DATE: 12.31.2012

■ **HOSPICE [TRC 01.03.2013]**

↻ Initial Review Note ↻

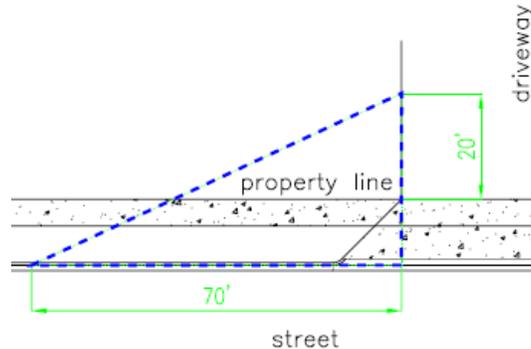
9. The City's 20'x70' sight distance triangle has not been applied properly. Please refer to the illustration below and revise the sight triangles accordingly. Show on the site plan and landscaping plan. [\[Sec.18-](#)

529(c)(3)CofW LDC] Add a note indicating that all proposed vegetation within sight triangles shall not interfere with clear visual sight lines from 30"-10'. [Sec.18-566 CofW LDC]
